WM Project

FOLLOW-UP COMMENTS ON MAY 22, 1985 BWIP/NRC HYDROLOGY MEETING:
CHANGES IN TESTING PLANS SINCE DECEMBER 1984

SUBJECT: LEONHART, ET AL., (1984): "ANALYSIS AND INTERPRETATION OF A
RECIRCULATING TRACER EXPERIMENT PERFORMED ON A BASALT FLOW
TOP"

Possible Effects of Hanford Site Wastewater Disposal Activities On the System of Confined Basalt and Interbed Aquifers

FIGURE 1. CONTOURS OF EQUAL HEAD BUILDUP, IN METERS, FOR HOMOGENEOUS AQUIFER AS DESCRIBED IN TEXT. PUMPING RATE 1 GAL/MIN. NEGATIVE BUILDUP IMPLIES DRAWDOWN. (DC-8 ON LEFT, DC-7 ON RIGHT). THEORETICAL RESULT, FROM NUMERICAL MODEL.

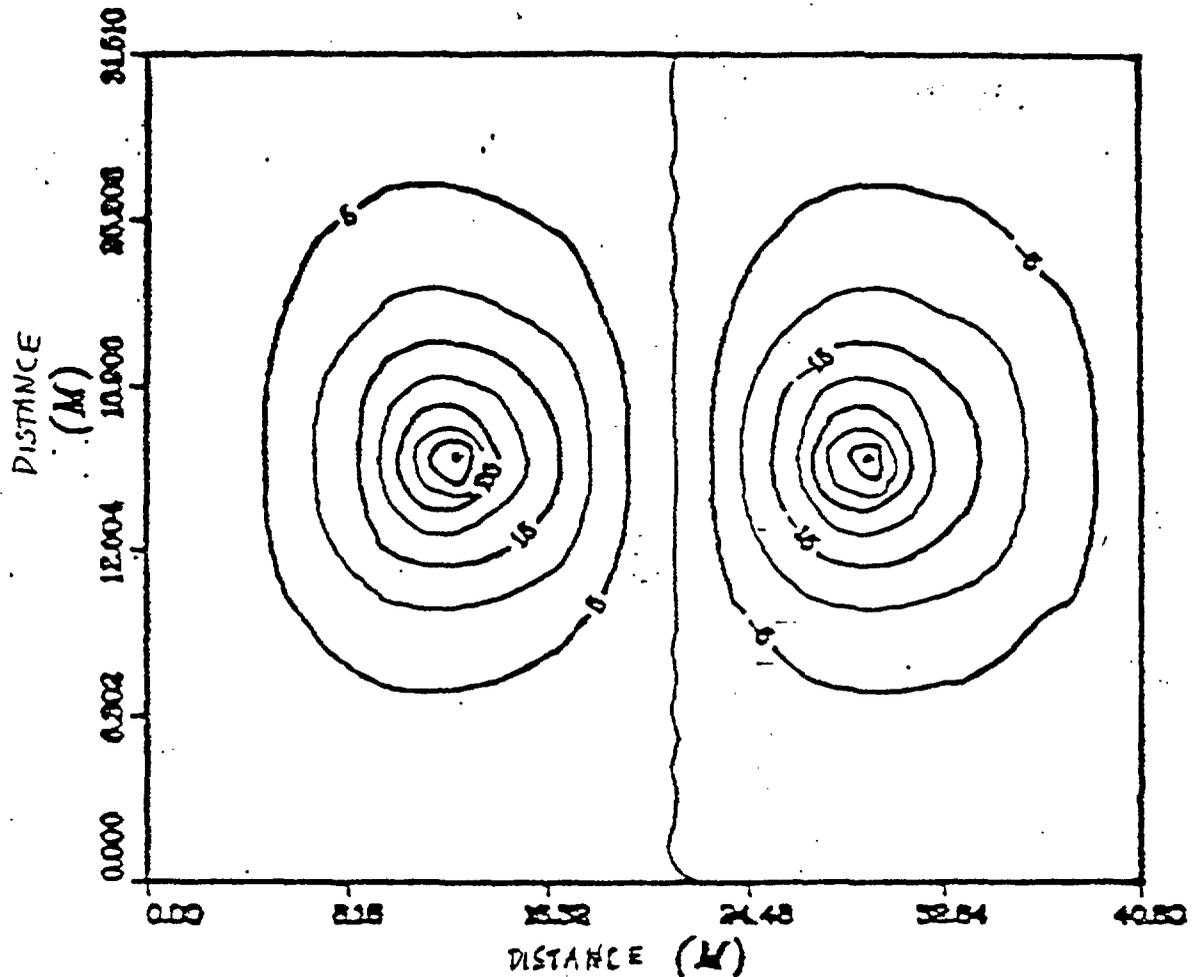
Assuming constant flow rates and an ideal homogeneous isotropic aquifer, the head impression and depression within the aquifer, but not necessarily within the well, would be expected to be symmetrical. The expected head distribution in the aquifer is illustrated in Figure 1, using the aquifer properties of Leonhart et al. (the figure and calculation is based on output from a numerical model, SWIFT, and a contouring post-processor; heads very close to the well are averaged across a larger grid block). However, a difference in the magnitude of drawdown/buildup within the boreholes themselves would in fact be expected due to the differing radii of the two wells: DC-7 being 0.11 m radius, and DC-8 being 0.04 m radius. (We note that inches have been inaccurately converted to centimeters on page 6 of the document.) The inequality in the observed borehole drawdown/buildup is, however, opposite to what would be expected theoretically, i.e., DC-8 (the smaller hole) had less buildup than DC-7 had drawdown. Assuming the value of aquifer transmissivity as noted in Leonhart et al., the expected drawdown in DC-7 would be about 67.3 meters at steady state, while the buildup in DC-8 would theoretically be about 81.5 meters (based on a calculation using equation 8-155 from Bear (1979)) for the 1 gal/min pumping/injection rates). Both of the observed drawdown/buildup magnitudes are less than would be expected theoretically; and the 0.61 m observed buildup at DC-8 is particularly inconsistent with the expected value. This could possibly be due to the aquifer having a higher transmissivity than assumed, with a local low transmissivity zone or wellbore skin near DC-7. Alternatively, a very conductive fracture or other heterogeneity may intercept DC-8 and not DC-7; however, this would seem inconsistent with the reasonably high recovery of tracer (60%) at DC-7. Similarly, a local pinch-out of a more transmissive horizon may also explain the observed drawdown/buildup, as reasoned by Leonhart et al. The presence of a wellbore skin at DC-7 is discounted by Leonhart et al., although no clear justification for doing so is presented in the document. During an attempted pump test at DC-7 prior to the tracer test, "excessive drawdown" (p. 7) was developed at DC-7; this may be consistent with what was

observed during the tracer test, and suggests that a skin effect or the presence of lateral heterogeneities are affecting the ground-water flow near DC-7. Another explanation could be that the flow top has a higher transmissivity than assumed, with a less permeable boundary or borehole skin effect near DC-7, causing a higher drawdown at DC-7 than the impression at DC-8. At any rate, given the irregularities in the observed drawdown and buildup, it is surprising that such an excellent fit to the type curve was obtained (Figure 8 of the report).

Figure 9 - Vertical head profile in borehole cluster DC-19 on May 27, 1984.

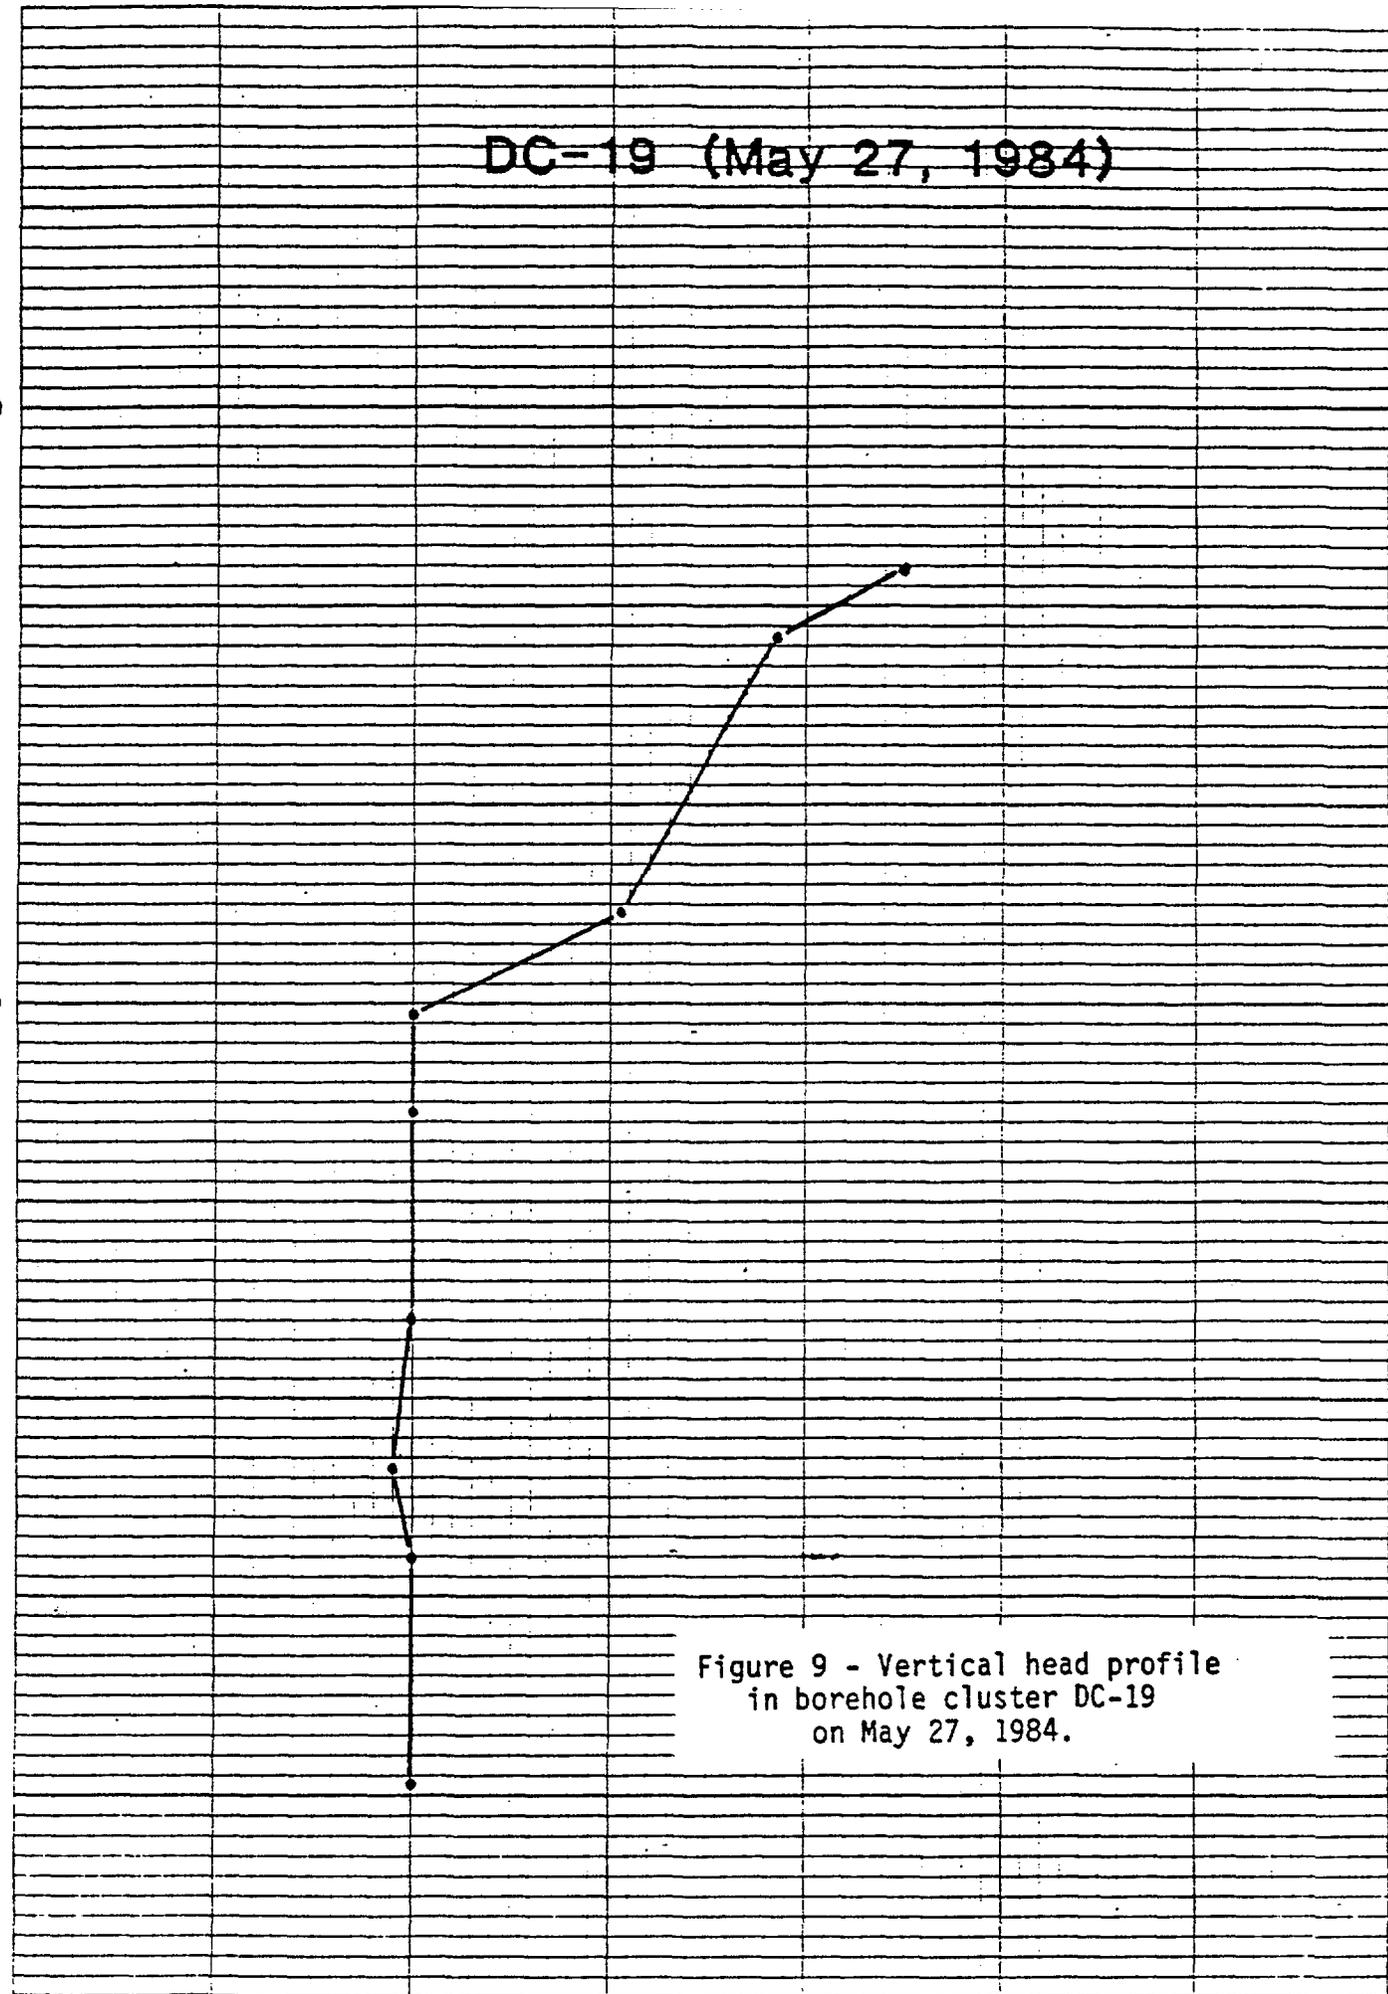
The NRC staff is concerned that these disposal activities may possibly have caused significant changes in the geohydrologic regime, including the confined basalt and interbed aquifers that underlie the RRL. Figure 5-41 of the SCR (1982) shows 10 hydraulic head measurements collected using drill and test techniques in borehole RRL-2, located in the heart of the RRL. As depicted in Figure 6, hydraulic heads decrease with depth from the Mabton Interbed down to the upper Grande Ronde basalts, then increase with depth down to the Umtanum Basalt (see Figure 7). As shown in Figure 5-40 of the SCR (1982) a similar trend reversal appears to exist in data from borehole DC-16A (see Figure 8). As shown in Figures 9-11, data from each of the newly constructed (1984) piezometer clusters at DC-19,20,22 show decreasing heads with depth down to the Priest Rapids Member of the Wanapum Basalt. These figures are based on data from Jackson et al. (1984) which are summarized in Table 1. Relative to the RRL, locations of boreholes discussed above are shown in Figure 12.

The pattern of these head variations with depth suggests transient hydrologic responses which constitute significant anomalies in the confined aquifer system. At present, we consider downward recharge to be the most likely explanation for these gradient changes at depth. It is entirely possible that we are observing a downwardly-progressing change in hydraulic heads in response to four decades of onsite liquid waste disposal. In other words, heads measured near the RRL, and perhaps at other locations on the Hanford Site, may not be representative of pre-1944 steady-state conditions.

Figure 13 - Vertical head profile at piezometer site DC-19.
(Source - Figure presented without modification from DOE/NRC [1984]).

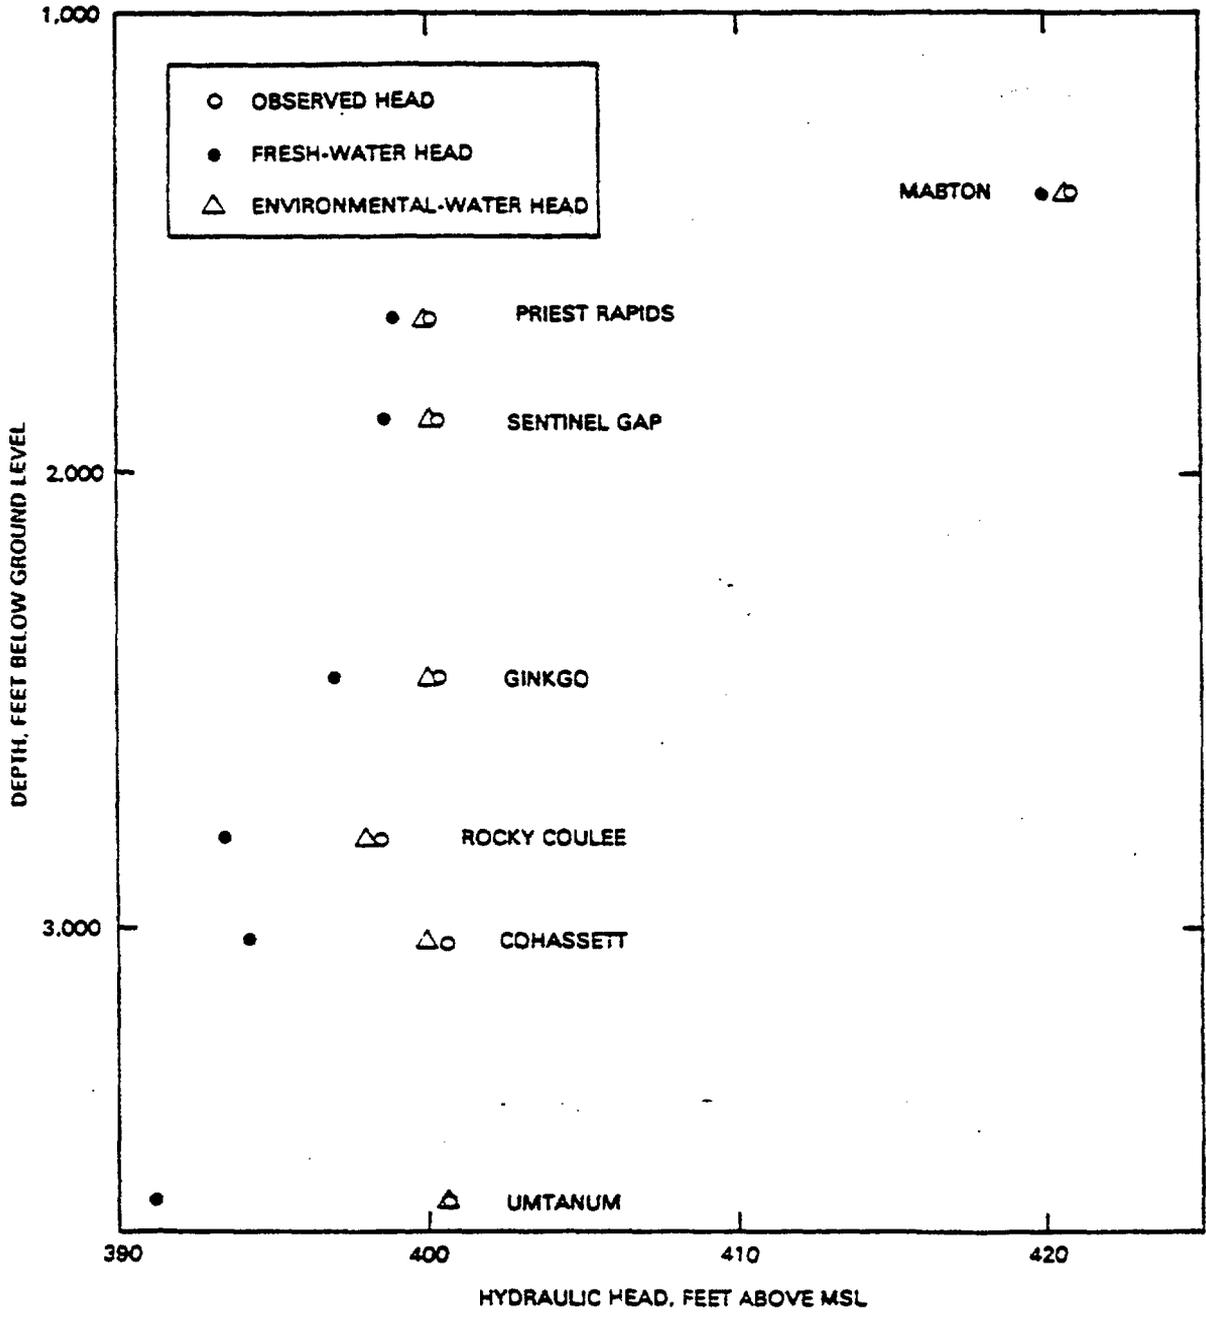
With regard to potentiometric measurements of deep aquifers, the NRC has previously stated concerns regarding the effects of variations in fluid temperatures and dissolved solids within wellbores (Wright et al., 1984). Two relevant figures presented by DOE in a recent meeting (DOE/NRC, 1984) are attached as Figures 13 and 14. According to the DOE staff, these figures show head measurements from the borehole clusters DC-19 and DC-22 and compare uncorrected heads with those corrected for fluid density variations ("environmental heads"). Based on these figures, it appears that "environmental heads" and uncorrected heads are similar because the corrections for temperature and dissolved constituents tend to cancel each other out. However, we cannot verify this phenomenon because the data used to perform the head corrections were not presented during the stated meeting. If the corrections used to obtain "environmental heads" prove to be valid and correct, then the measured vertical head profiles would provide greater confidence in the existence of the hydrologic anomalies discussed above.
